123 18th Ave East
Multifamily Apartment Building
Design Review Recommendation Meeting

ADDRESS:	123 18th Avenue East Seattle, WA 98122
DPD PROJECT NUMBER:	3014594
APARTMENT UNITS:	67
PARKING:	36 Spaces
BICYCLE STORAGE:	54 Bicycles
GROSS RENTABLE SQ. FT.:	36,634 sq. ft.
PARKING GARAGE SQ. FT.:	9,714 sq. ft.
BICYCLE STORAGE SQ. FT.:	521 sq. ft.
GROSS BUILDING SQ. FT.:	56,901 sq. ft.
AMENITY SPACE:	7,746 sq
SITE AREA:	18,672 sq. ft.
FLOOR AREA RATIO:	2.0
ALLOWABLE FLOOR AREA:	18,672 sq. ft. X FAR (2.0) = 37,344 sq. ft. Allowable Floor Area
OWNER:	Odegard Gockel Development LLC. P.O. Box 807 Bellevue, WA 98009 425.454.3282
APPLICANT:	Bazan Architects 2000 116th Avenue Northeast, Suite 4 Bellevue, WA 98004 Marc Jenefsky, AIA, NCARB, LEED AP 425.637. 0831 marcjenefsky@bazanarchitects.com www.bazanarchitects.com

ORIGINAL EDG THEME'S COMPARISON

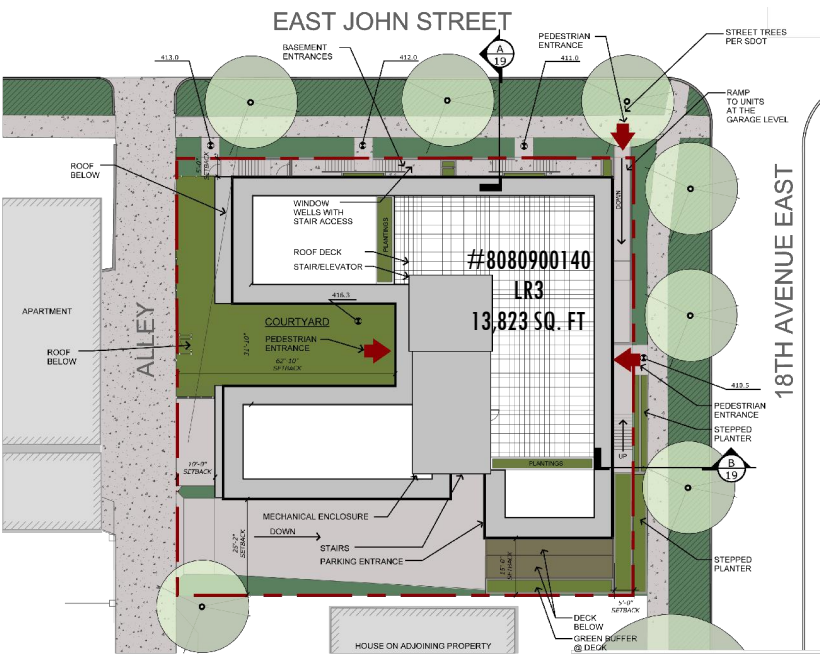
After our Early Design Guidance meeting and presentation we were instructed by the Board to proceed to the MUP submittal phase. During this time our client purchased the neighboring 4,849 sq. ft. lot to the south. Combining these two parcels increased our lot size from 13,823 sq. ft. to 18,672. This change increased the mass of our building but did not effect the main themes discussed in our EDG meeting.

SOUTHERN SETBACK DIAGRAM

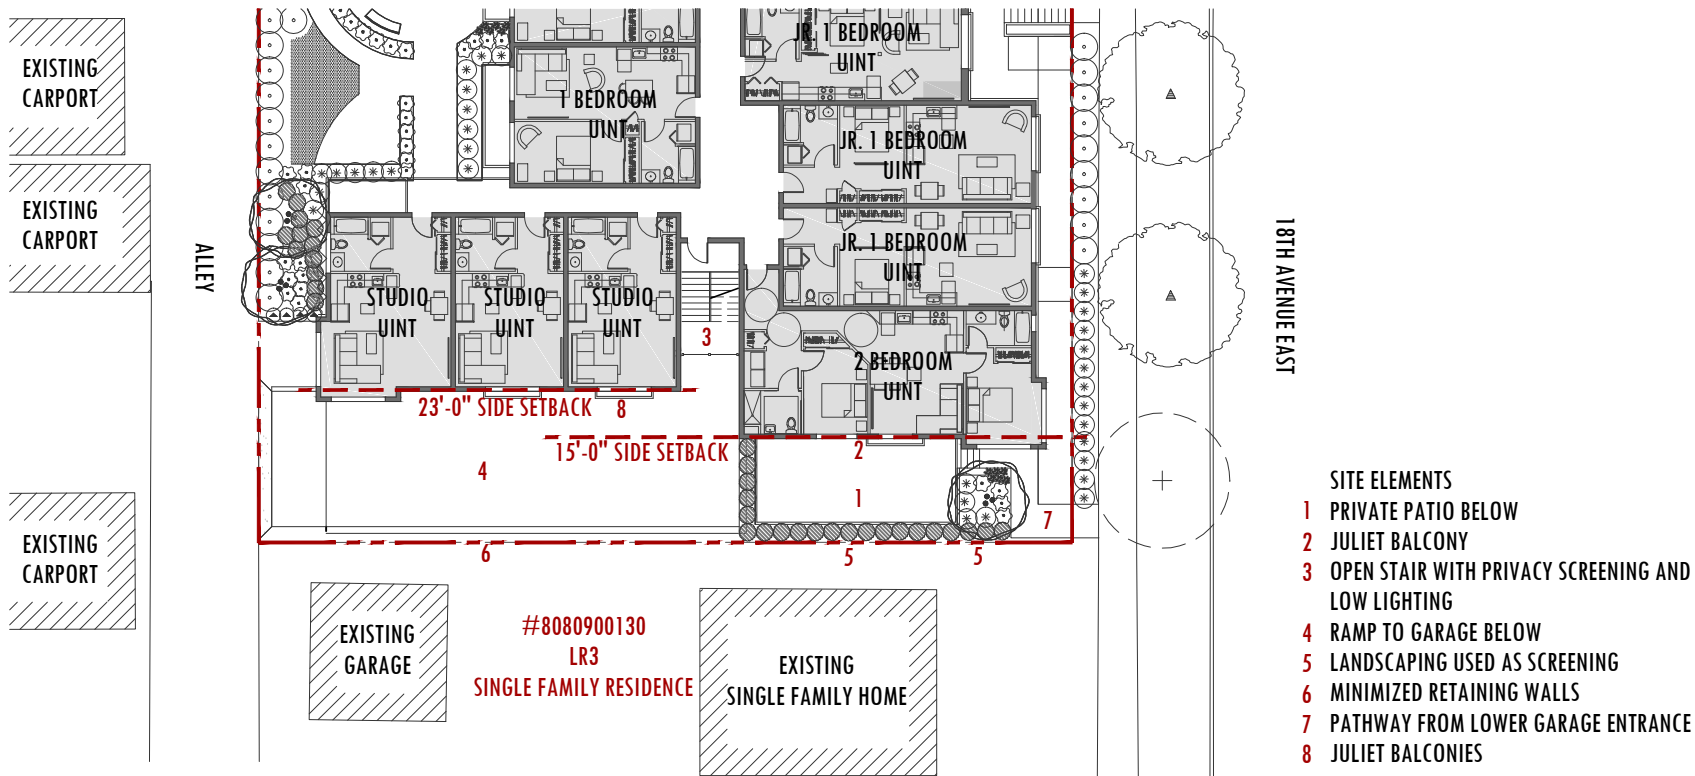
The preferred alternative was revised to the Early Design Guidance Meeting to provide 15 foot south side setback between the proposed structure and the south property line. Upper level usable decks were removed and replaced by Juliet Balconies. The Board preferred the revision to mitigate impacts on privacy and bulk to the adjacent structure. the revised massing proposal should be maintained as the design progresses. (A-5, B-1).

An agreement was made early in the design process with the neighbor to the south to set our building back 15 ft. from the souther property line. The purpose of this is to provide increased privacy and a buffer to reduce noise, light and reduce the overall impact on this property. Several features were included in our EDG package to accomplish this. The building has been setback and modulated to push the building away from the property as much as possible. The units facing the the southeast corner of the building have been setback to the requested 15 ft. with reduced balconies on the upper three floors. The unit on the ground floor has a large private patio, however, we will provide lush landscaping along the property line to provide screening and there will be only a limited number of residents that utilize this private patio. At the southwest corner of the property we have used our garage ramp as a setback of 23 ft. As our design progressed and the lot increased in size we have maintained these setbacks and buffers for the single family residence.

NORTHERN SETBACK DIAGRAM

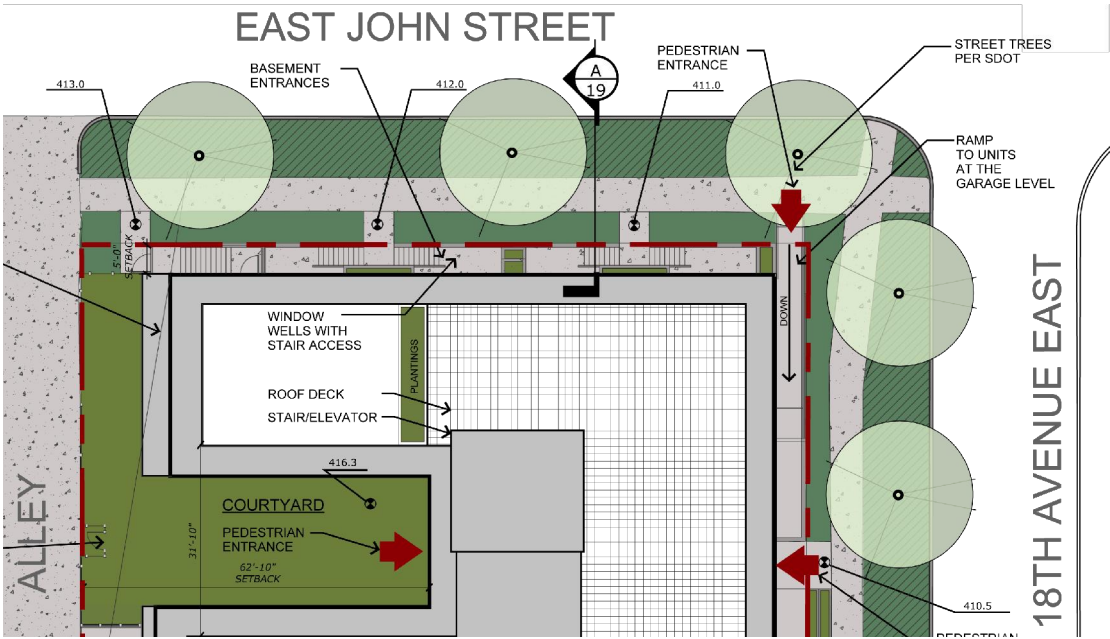
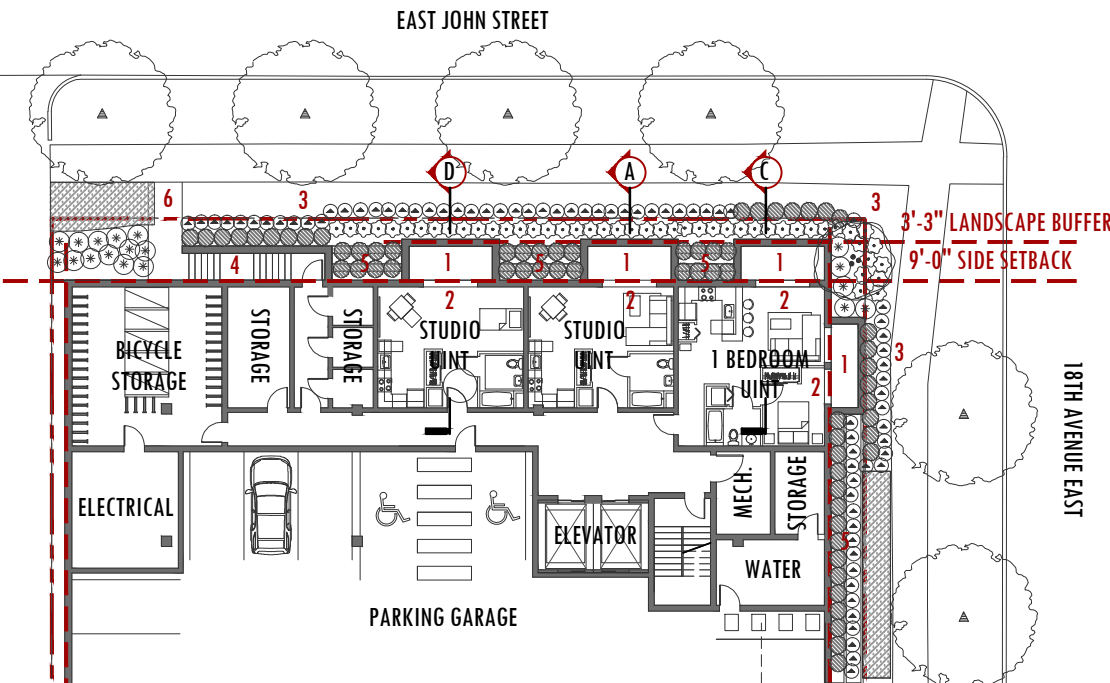
- A number of subterranean units are proposed facing and with direct access to E. John Street. Setbacks provided at the perimeter of the site should be developed to provide safe semi-private access.

- The Board was concerned about the viability of units below grade. The proposed subterranean entrances along E. John Street must be developed with sufficient width to provide viable, safe defensible space with secure entry points for residents. entrances must incorporate security measure to ensure personal security and also provide welcoming spaces for users. (A-3, A-6, D-7).

- The Board noted that provided stairwells must have lighting at all times of day. During daylight hours the stairwells must be designed to allow natural light. At night the space must include low level lighting to avoid dark hiding spaces. (D-7).

- The Board noted the extensive street landscaping present on site and withing the existing neighborhood context. The Board encouraged the applicant to utilize the setback space on site and within the right-of-way to provide a dense landscaping area and maintain landscaping "lushness" consistent with the adjacent streetscape. (E-1).

- At the next meeting, the Board wished to see additional details for the treatment of the subterranean access and sidewalk experience. The Board requested imagery and drawings from the sidewalk and stair well locations. The Board encouraged the applicant to research successful case studies and examples of similar conditions to inform the design including key architectural and landscaping features that create successful spaces. (A-2, A-3, A-6, D-7).

- The Board felt the street setback should include a combination of landscaping, planters, fencing, lighting and pathways that enhance the pedestrian environment. The Board suggested the applicant research use of simplified to maximize the landscaping space provided. (A-2, A-3, A-6, D-7).

We agreed with several of the Board's comments in this area and our design changed during the MUP Submittal process. We agreed that the amount of concrete involved in creating several stairways and wells along E. John St. would limit the amount of landscaping and other soft site features. In order to maintain the lush feel of the streetscape along E. John we first decided to remove the stair wells. This allowed us to increase the landscaping and reduce the height of the fencing around the wells. We performed several studies of the lighting in this area at different times of the year and under different conditions. These wells are on the north side of the building and will have difficulty receiving any direct sunlight especially during the winter months. Lack of light, security and usability made patios less desirable. We added high windows with shallow wells and eliminated the unit with the deepest window well. We have devised a system of shallow wells that have minimal height railings surrounded with lush landscaping that will allow units as much light as possible while maintaining the lush landscaping on the site.

MODIFIED MASSING - ENTRY LAYOUT

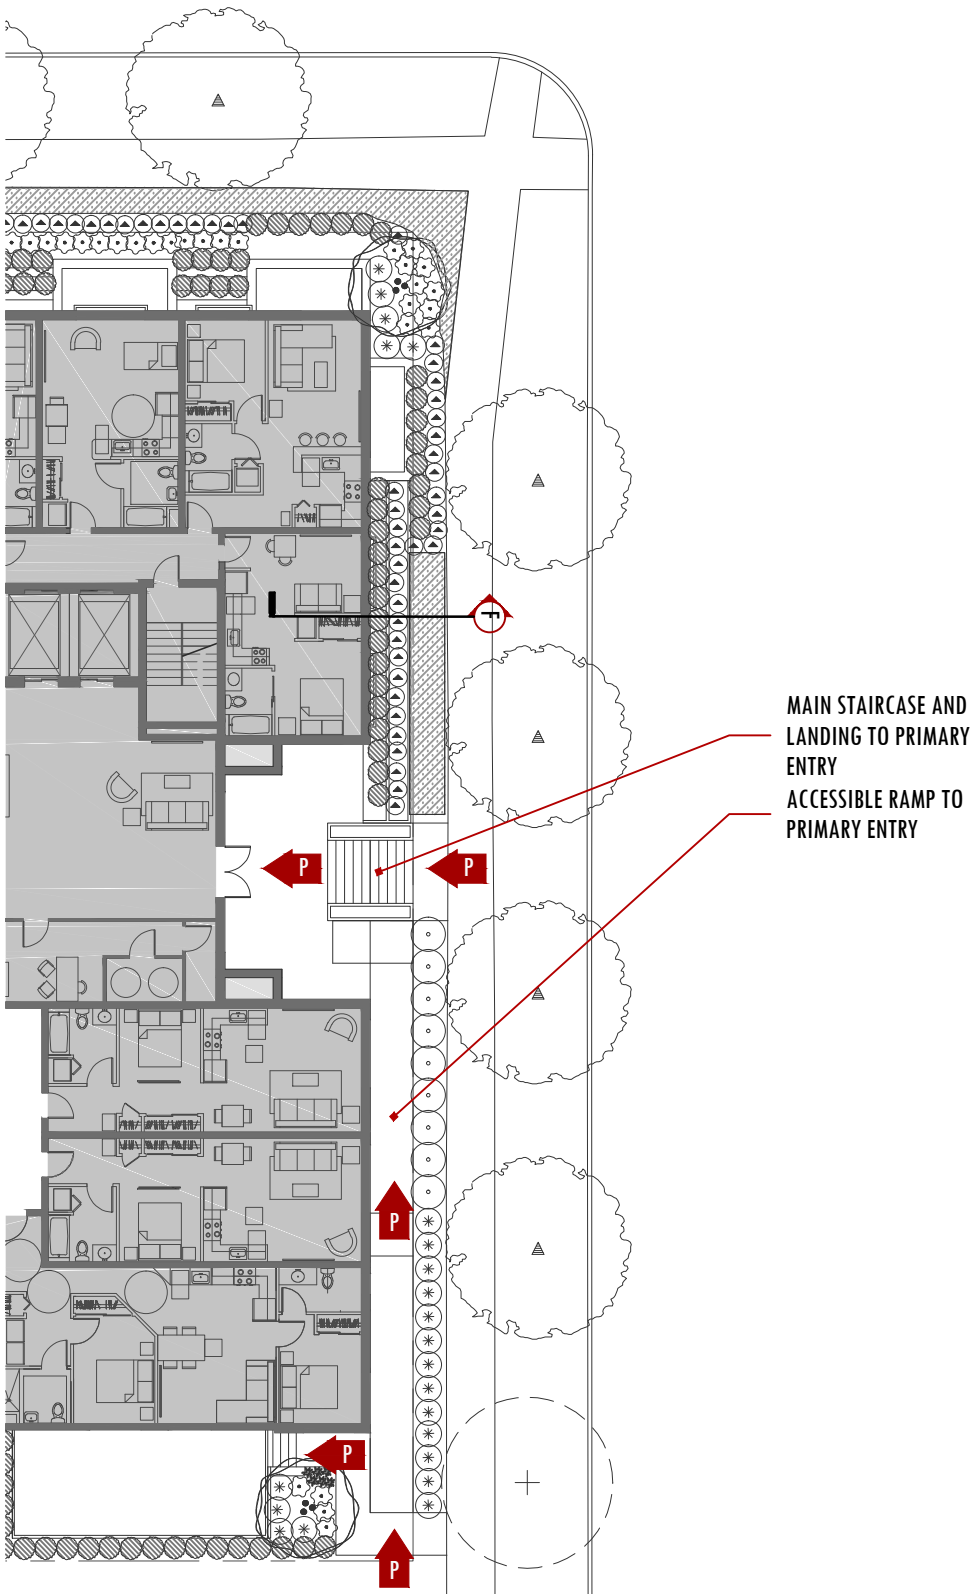
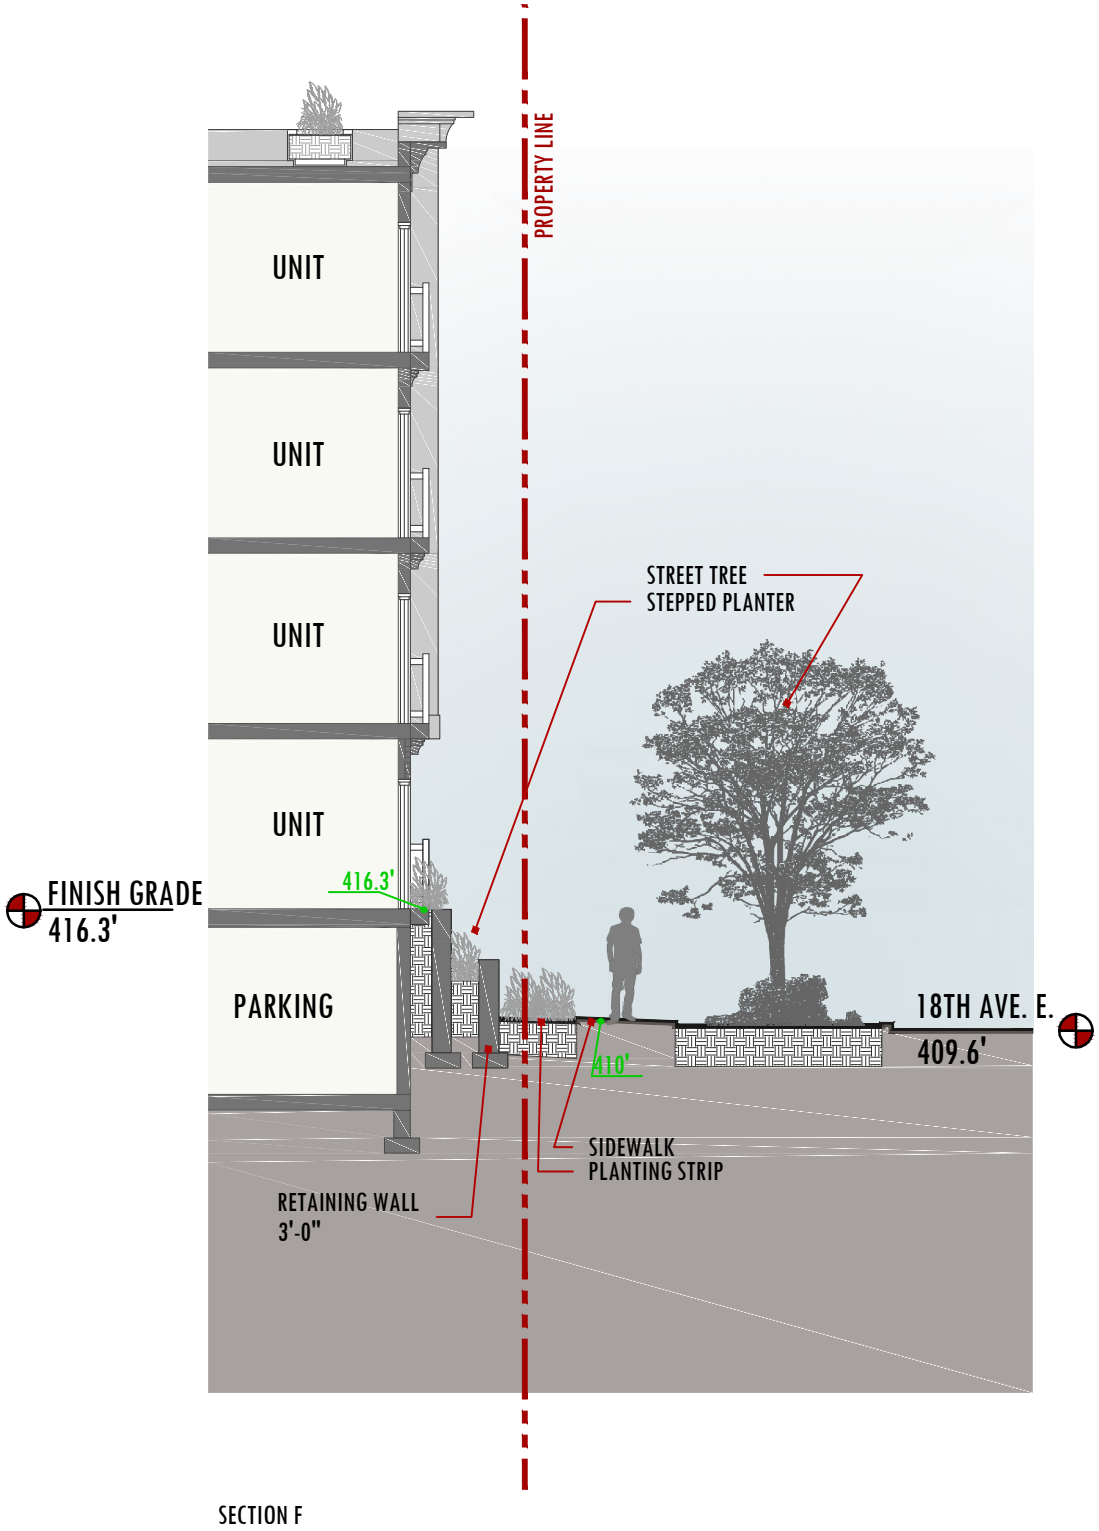
- The Board requested more detail on how the primary entry will be accessed from the street given the substantial grade change. The preferred massing alternative located the entry stair provided parallel to the building facade and sidewalk rather than as a direct approach. The Board requested the applicant review the placement of entry stairs to minimize the grade transition and provide direct, gracious stair approach to the primary entry (A-3 and A-6).

- The Board felt the design of the primary entry on 18th Avenue should be integrated with existing the overall design parti while encouraging a strong point of entry consistent with existing neighborhood context. (A-3, A-1, C-2).

- The Board encouraged the use of a landscaping transition between the building and the street property line. The Board noted that larger planters provide opportunities for denser landscaping, but the project must also limit height of retaining walls to provide human scale pedestrian experience along the street. (D-3, E-1, E-2).

We agreed with the Board's comments. We have redesigned our entry into a grand staircase similar to the apartment buildings in the surrounding neighborhoods. We removed the ramp and canopy at the corner of 18th and John. We consolidated our entries. Consolidating our entries would mean building a large accessible ramp in the front of our building. This ramp allows us to have one primary entry for all of our residents and guests. We believe that our grand staircase design along with our accessible ramp complements of overall design parti and helps our building relate to the existing neighborhood context. We have also taken the Board's advice and created landscape buffers to soften our transition to the Right-of-Way. We have maintained our large planters along 18th Avenue. We understand that reducing the height of these planters will aid to scaling our building, however, these planters are required to maintain our base height measurement. We also recessed the entry and faced it with brick for the entire facade. Again creating a sense of arrival.

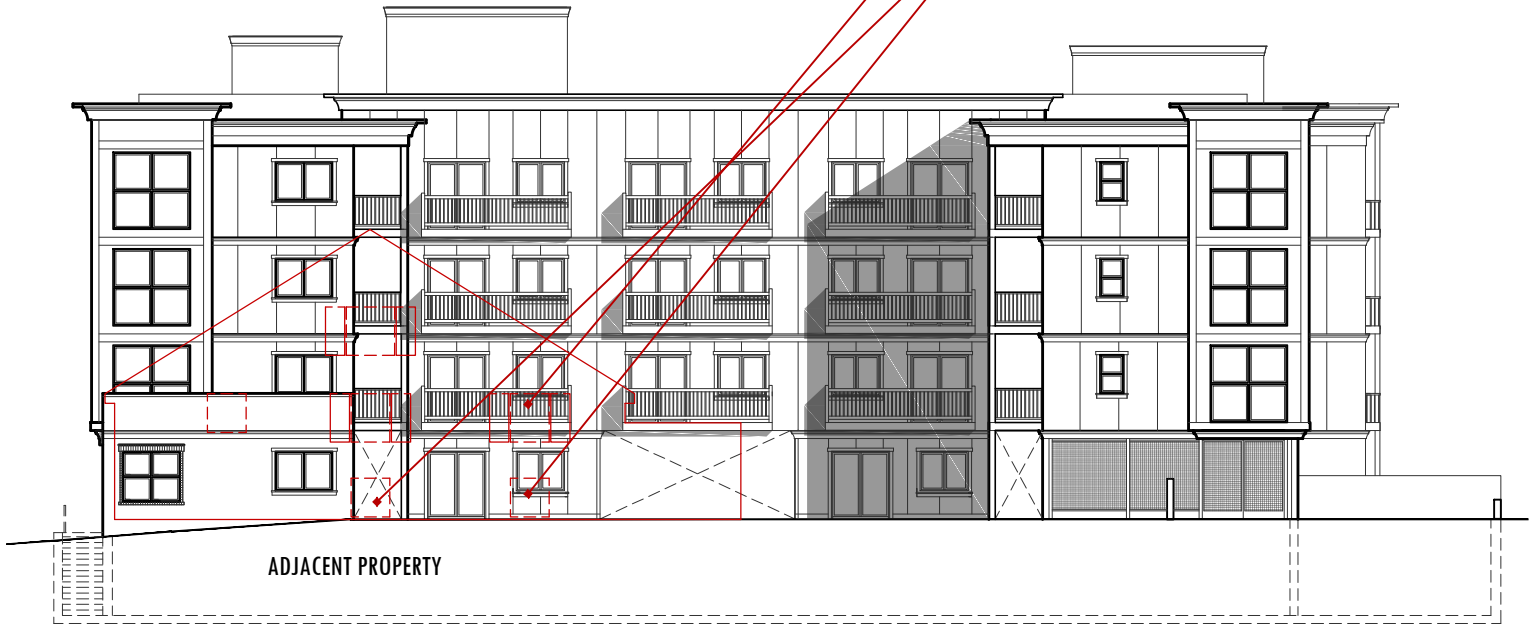
There are also concerns that the neighbor to the west would be impacted by the proposed structure. The Board asked that we would do a privacy study of this structure as well.

After conducting our study of the neighboring building we found that there are several windows that almost all of the windows will have little impact on the site to the west side of our building. The building is a recently remodeled single family home and lies about 30' from the closest facade of our building. There are two windows at grade that will look directly at our courtyard fencing which will wrap the courtyard. This fencing will be roughly 6'-0" tall and will wrap the extensively planted courtyard which will shield any viewing for the first 8'-0" in height. On the first floor of the building there are three windows. These windows will look directly at our at our balcony and corridors. The window furthest to the right will have a line of sight with the balcony of one of the second floor units that is approximately 60' from the window. We believe that the balcony, roller shades and the distance from the unit will prevent the invasion of privacy. The window on the second floor of the neighboring structure will have a line of sight with the third floor corridor. Again we believe that the privacy features we will be implementing and the sheer distance from the property will provide sufficient privacy. We will be providing roller shades to all of our units which should protect privacy while the shades are pulled.
